MYSO, LLC
Response to Siting Board Staff's First Request for Information
Case No. 2025-00395

Cumulative Environmental Assessment

Mayfield Solar Project
Graves County, Kentucky

| DATE | REV. | REVISION HISTORY | DRN. BY | CKD. BY | APPD. BY |
|---------------|------------------|-------------------|---------|---------|----------|
| DRAWING TITLE | | FENCEDD ARRAY MAP | | | |

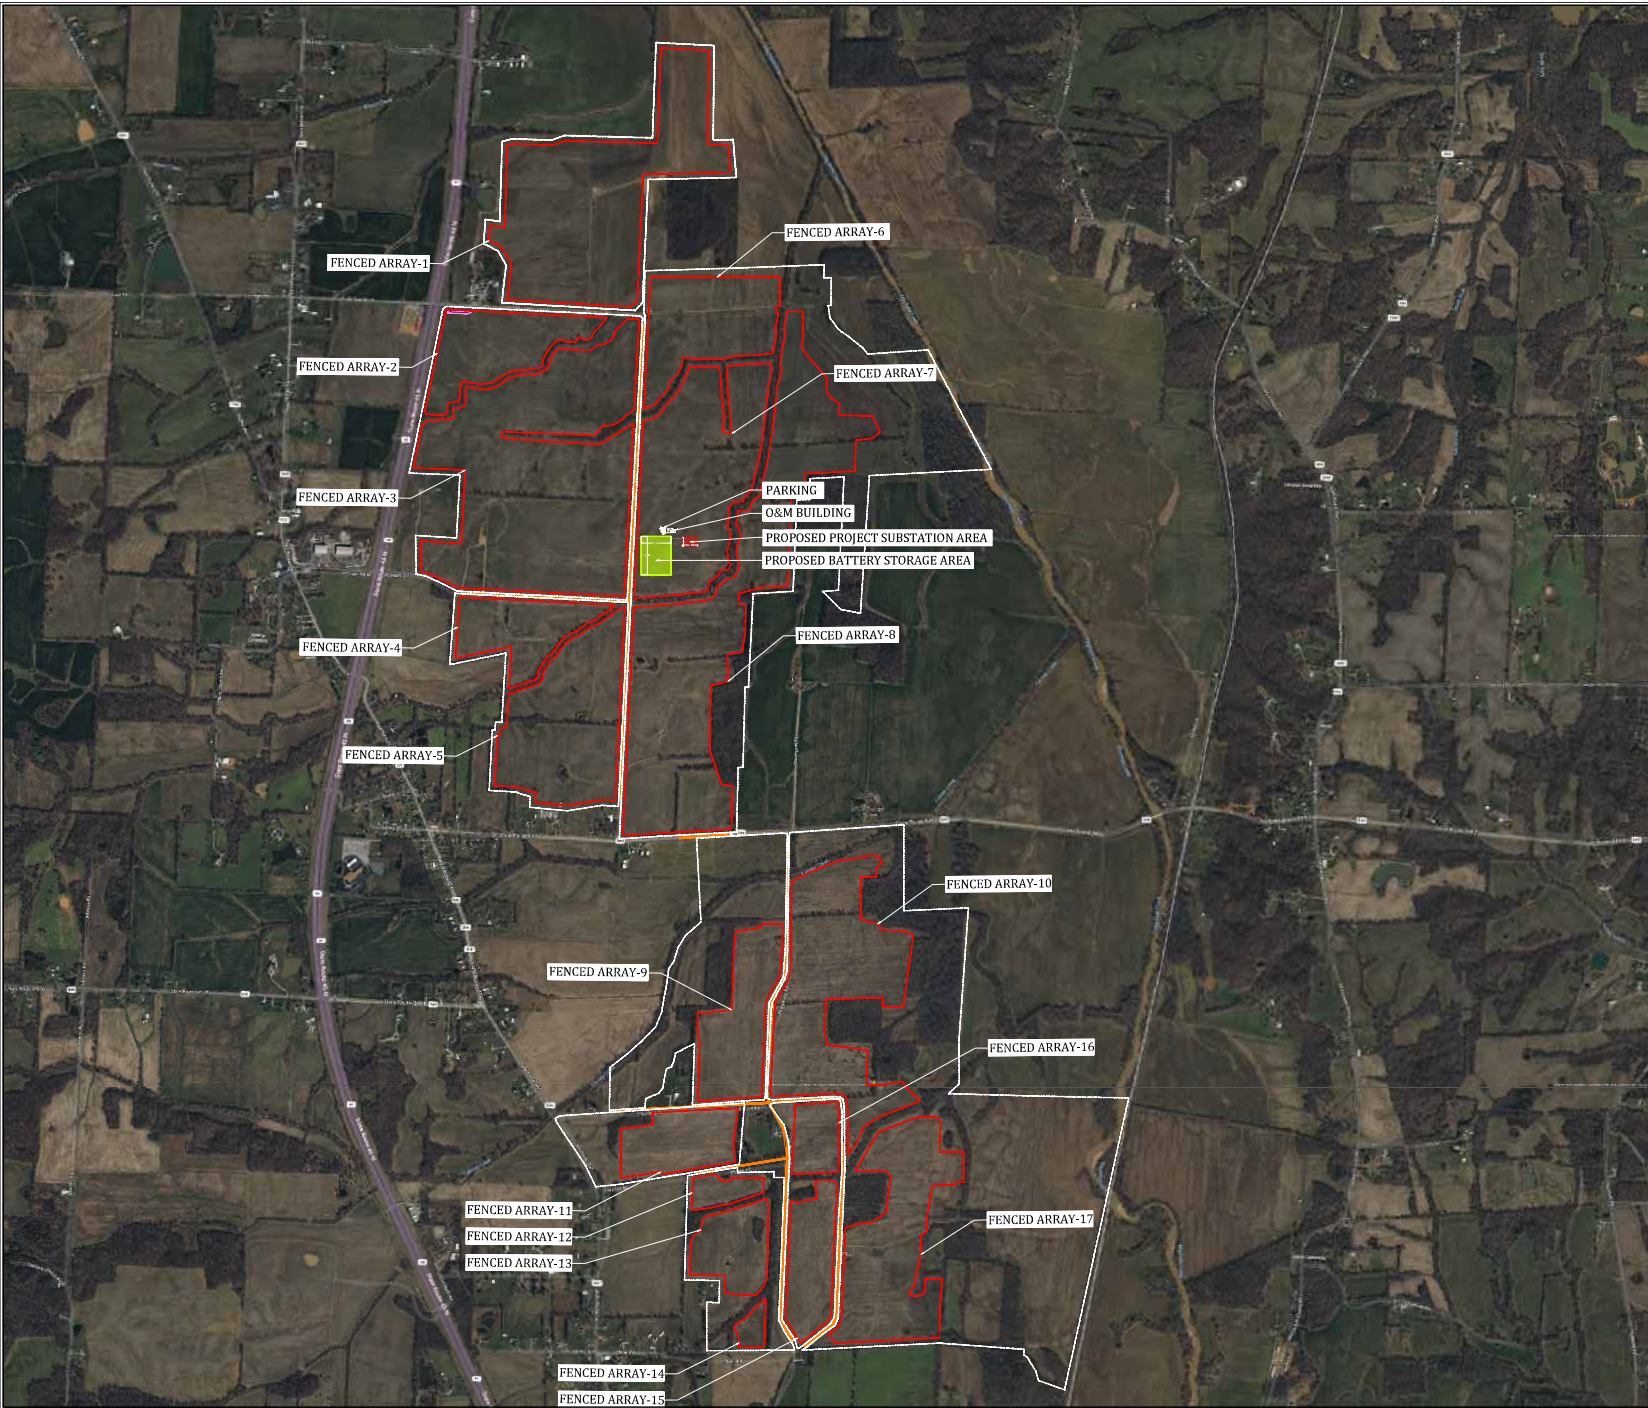
Refer to Exhibit H, Site Assessment Report (SAR), Attachment A (Site Plan), Plan Layout.

Provide the total number of individually fenced parcels of solar arrays. Provide a version of the Plan Layout map that identifies each of the fenced parcels of arrays with a number.

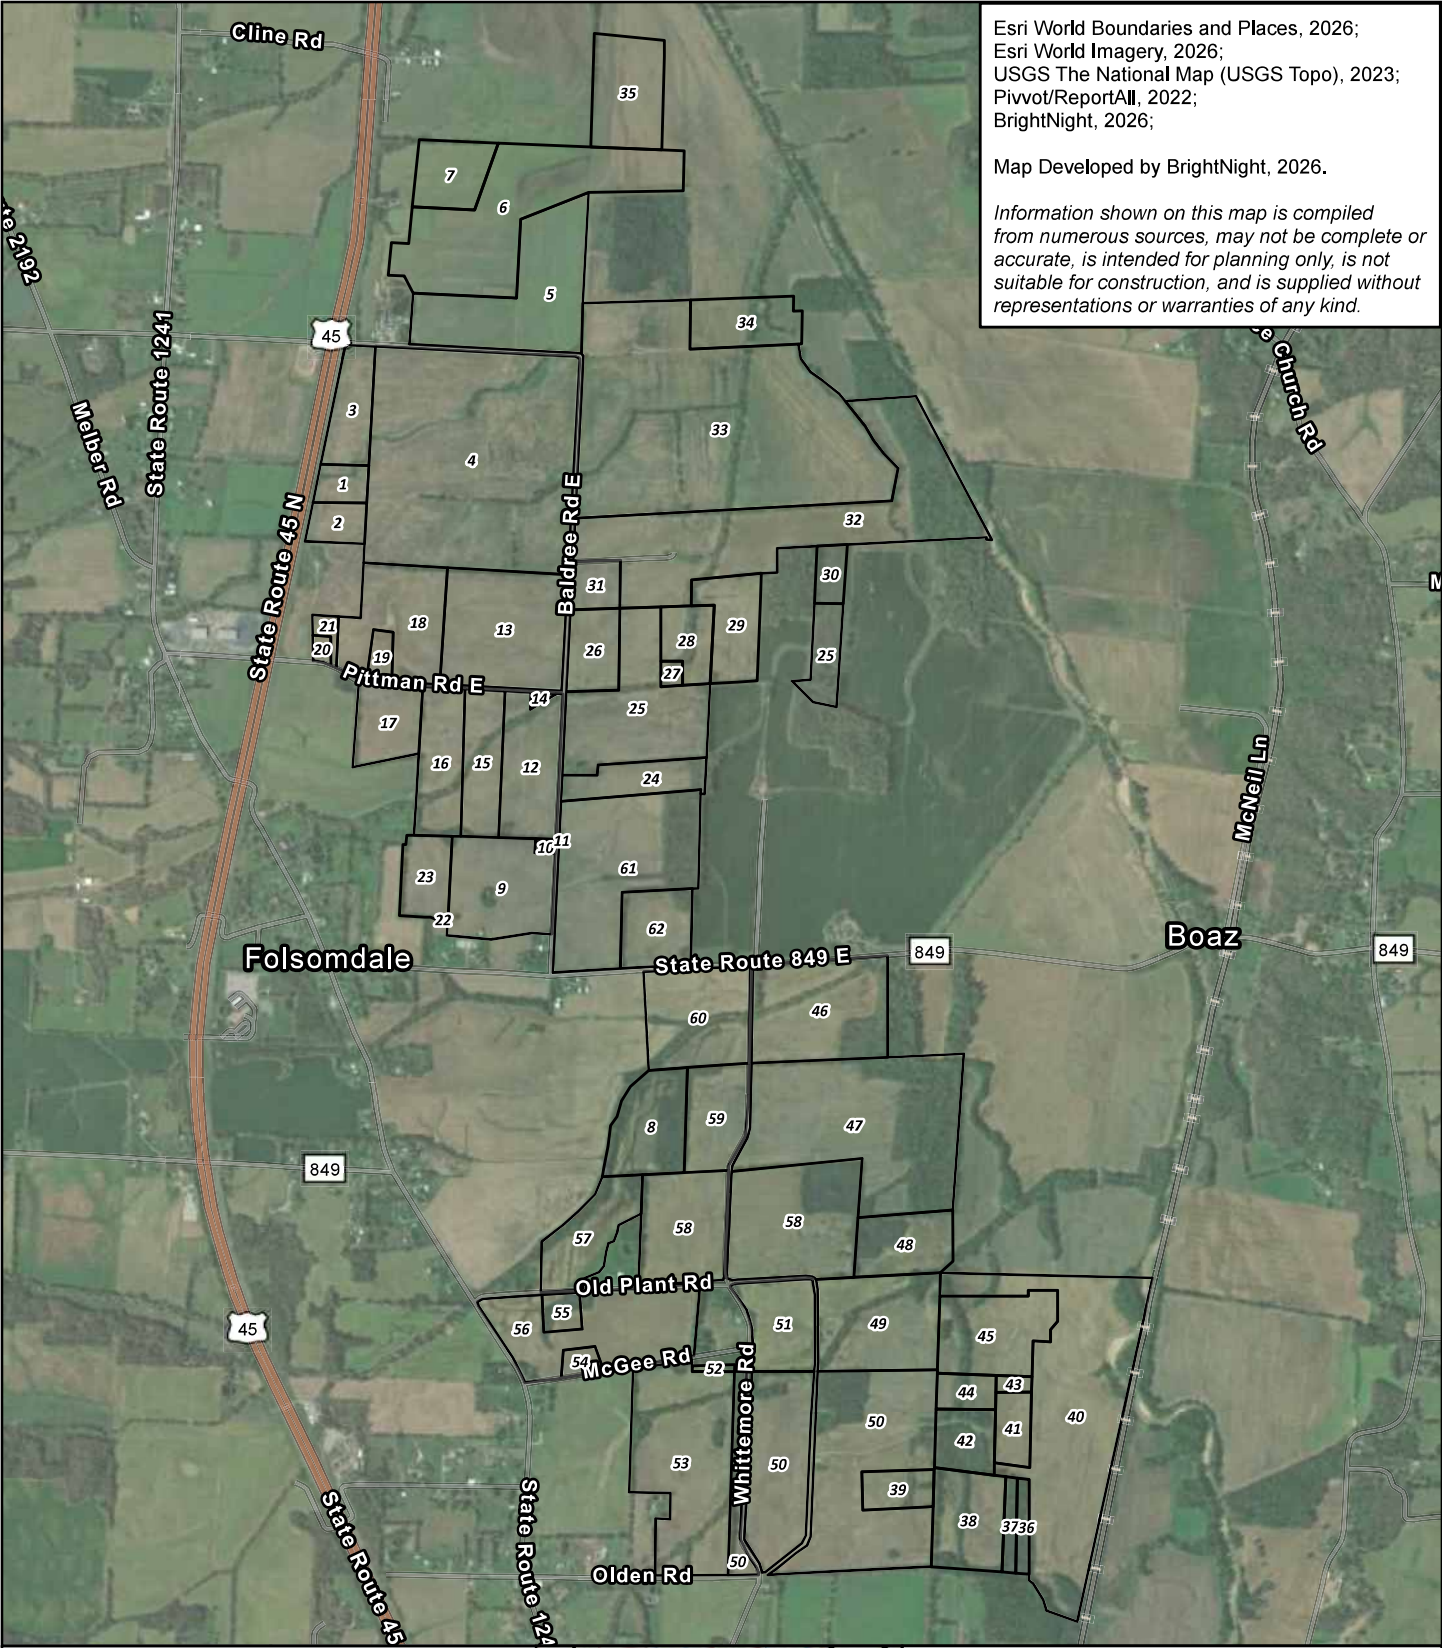
Refer to Exhibit H, SAR, Attachment C, Legal Boundaries. Provide a version of the Legal Description Inventory Overview. Include an aerial map with the parcels labeled from 1 to 62, according to the parcel descriptions in the attachment (i.e., "Parcel 1").

| DATE | REV. | REVISION HISTORY | DRN. BY | CKD. BY | APPD. BY |
|---------------|------------------|-------------------|---------|---------|----------|
| DRAWING TITLE | | ENTRANCE MAP | | | |

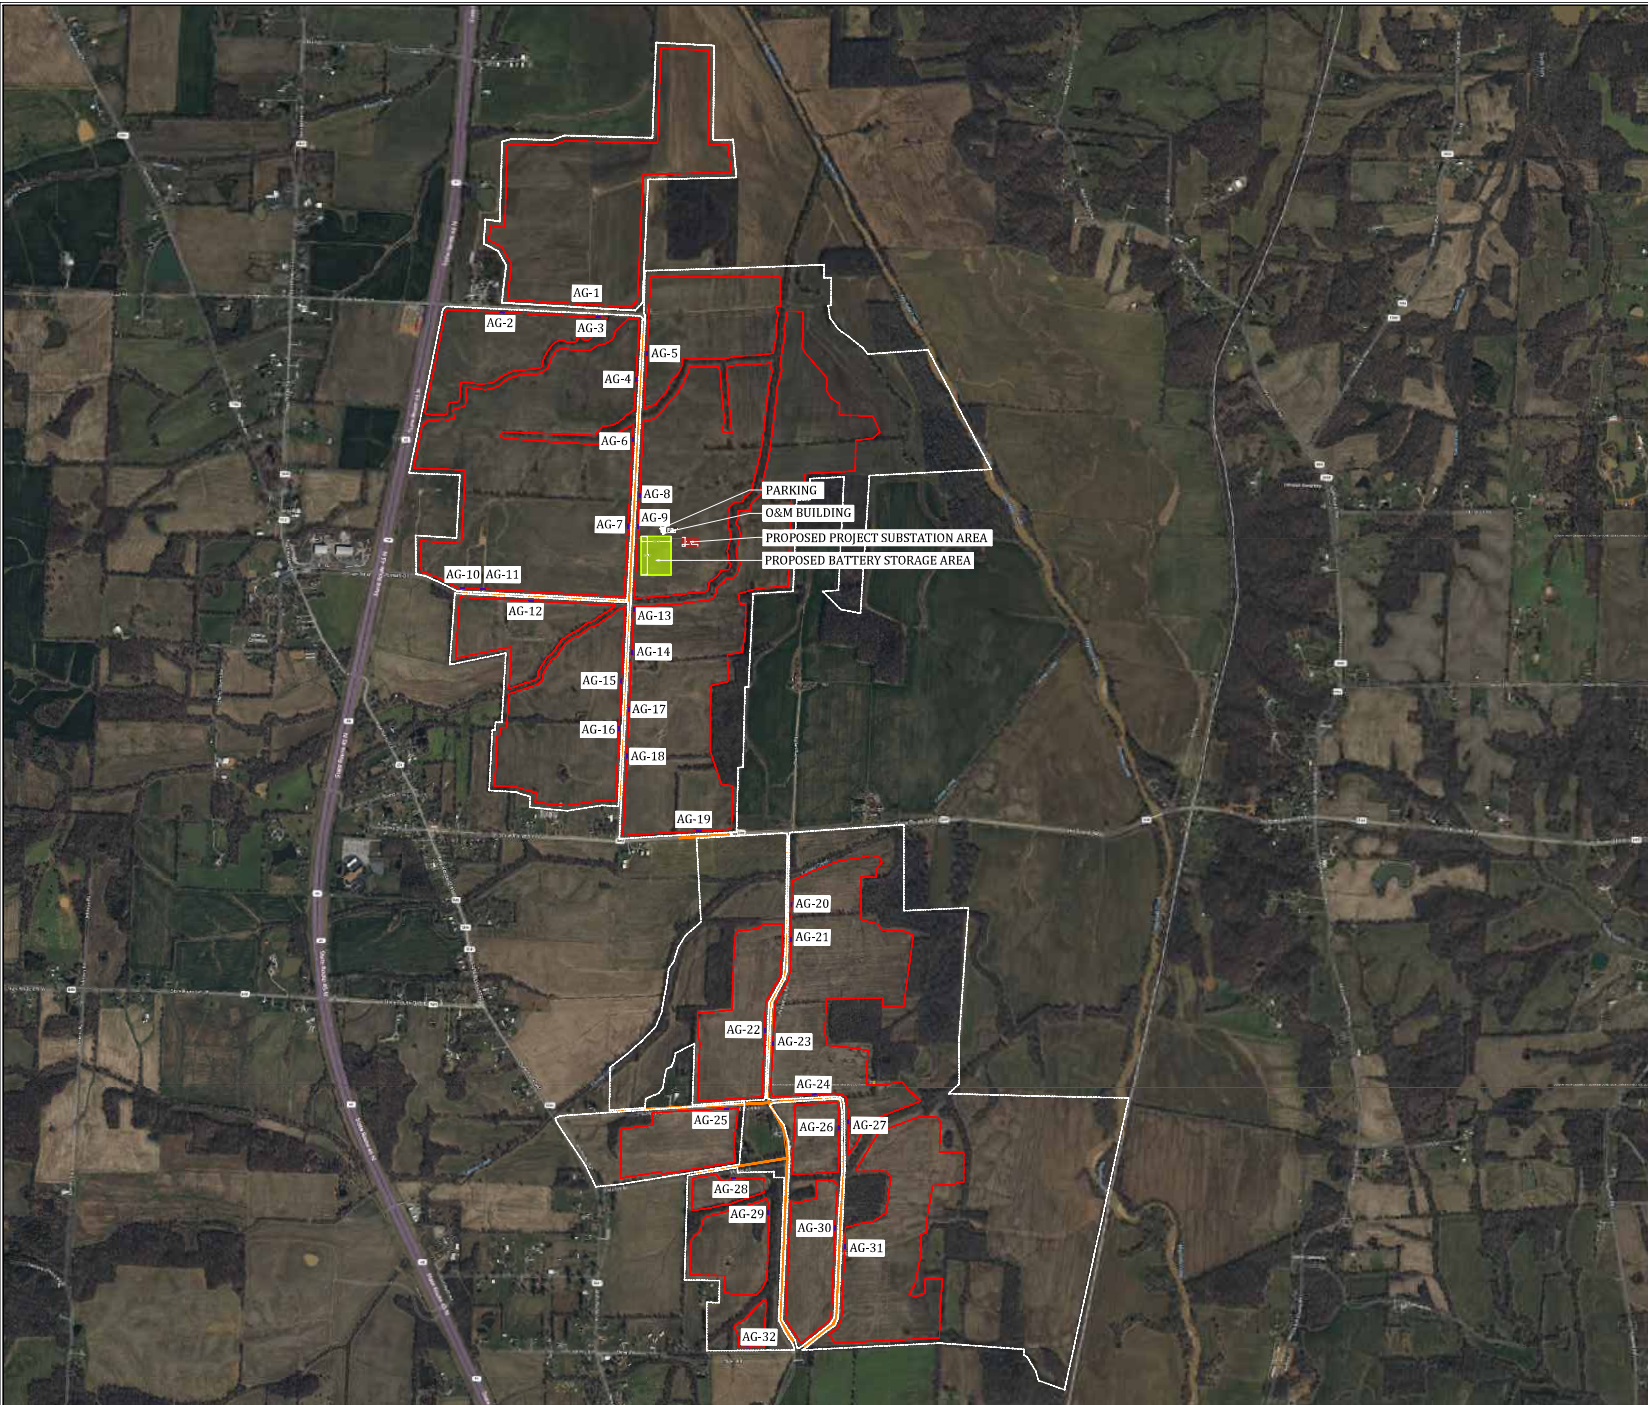
Refer to Exhibit H, SAR, Attachment A, Site Plan Layout.

- a. Provide the total number of site access entrances in use during the construction phase.
- b. Provide a narrative description of each construction entrance location.
- c. Provide a revised Plant Layout map if these locations have changed.

- a. See Response No. 5(a) above.
- b. See Response No. 5(a) above.
- c. See attached.

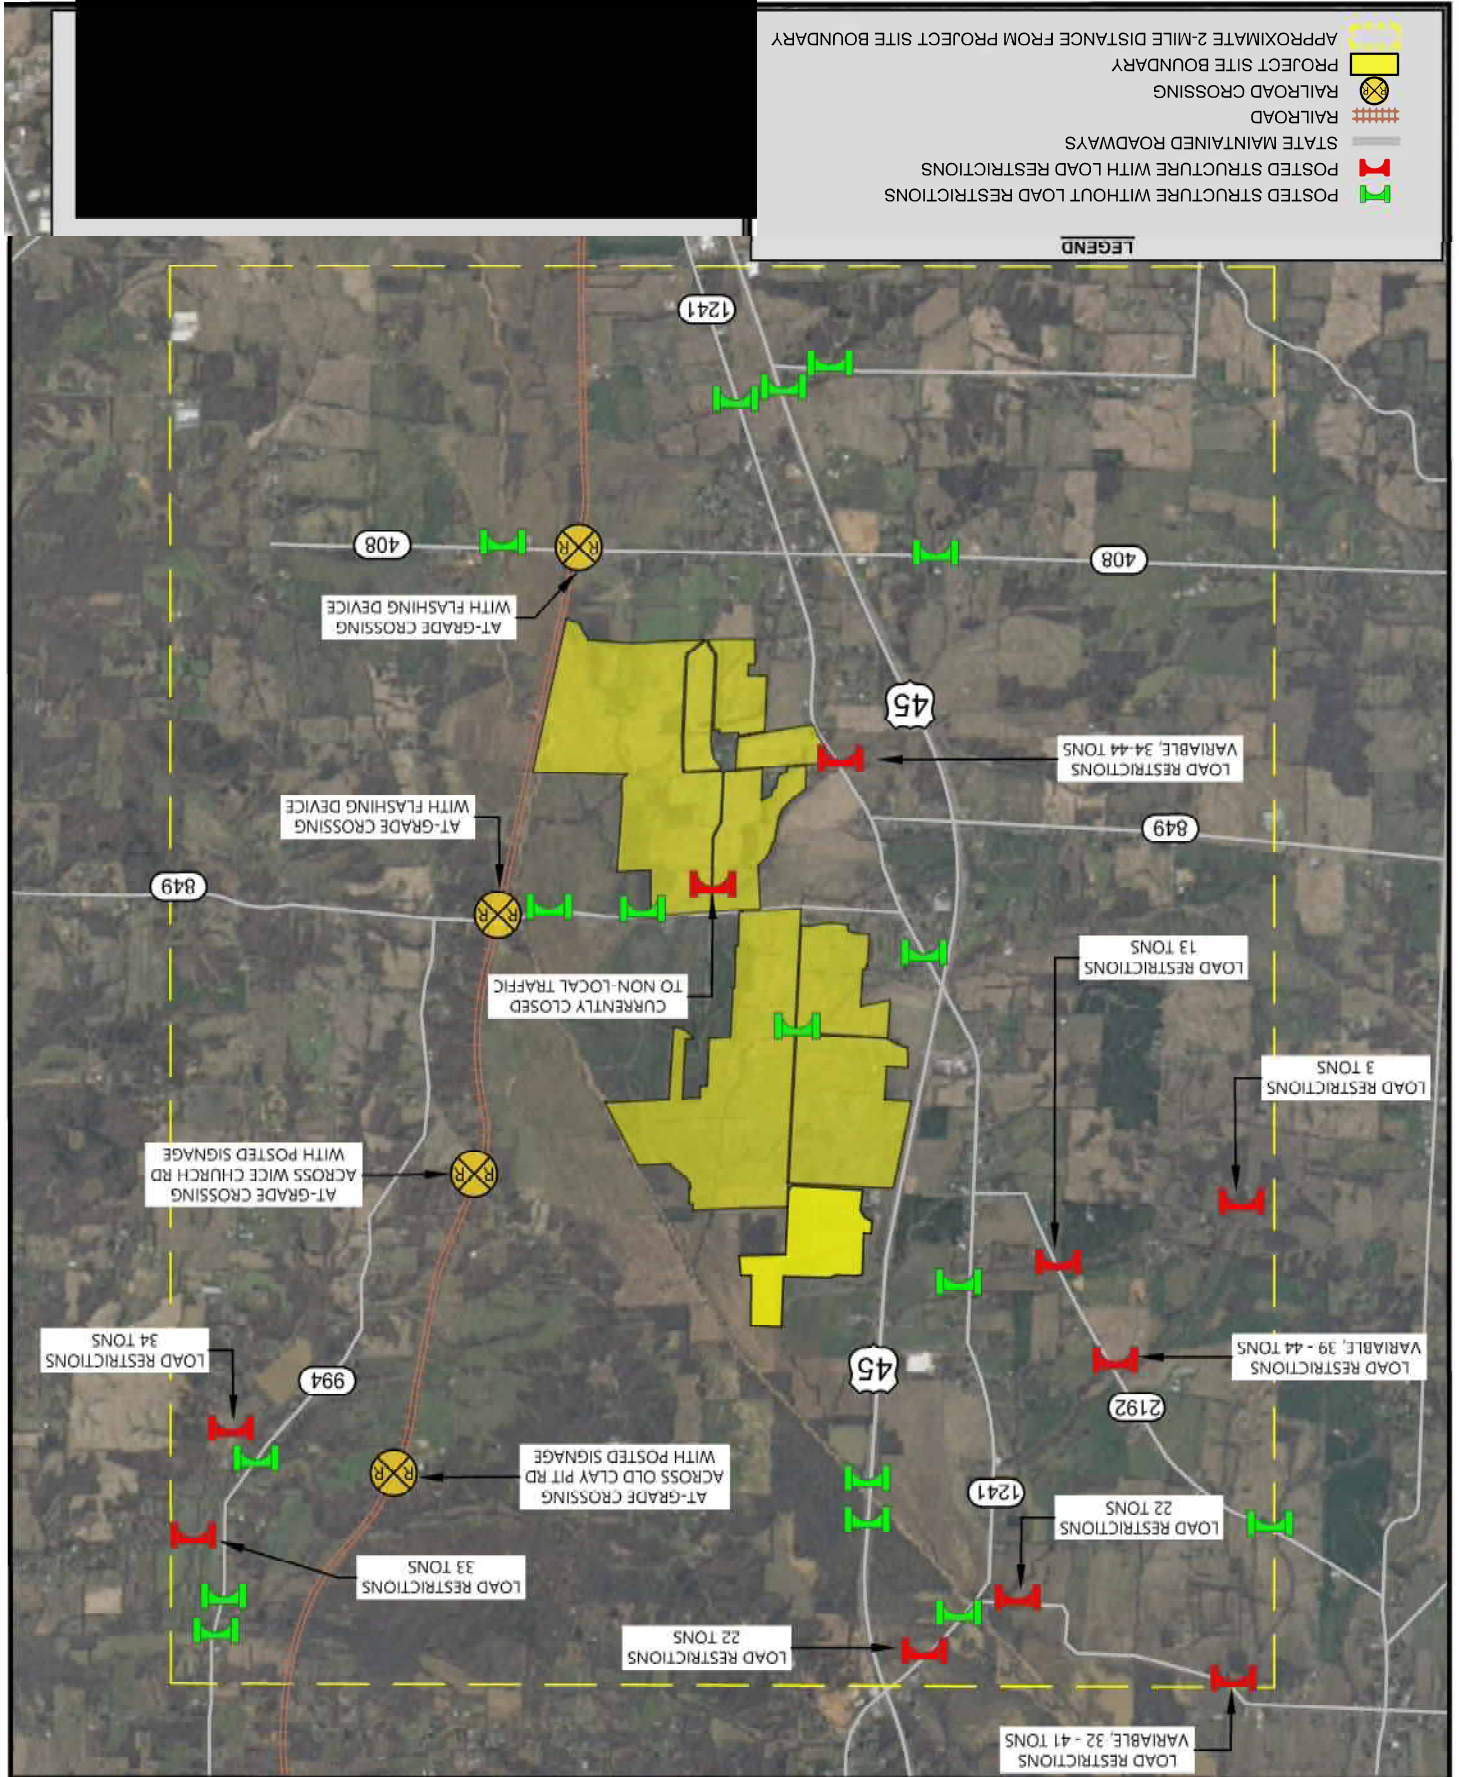
Provide a map of all railroad crossings within two miles of the Project area including details for each crossing (type of crossing, weight limit, warning/control devices, etc.).

See attached.
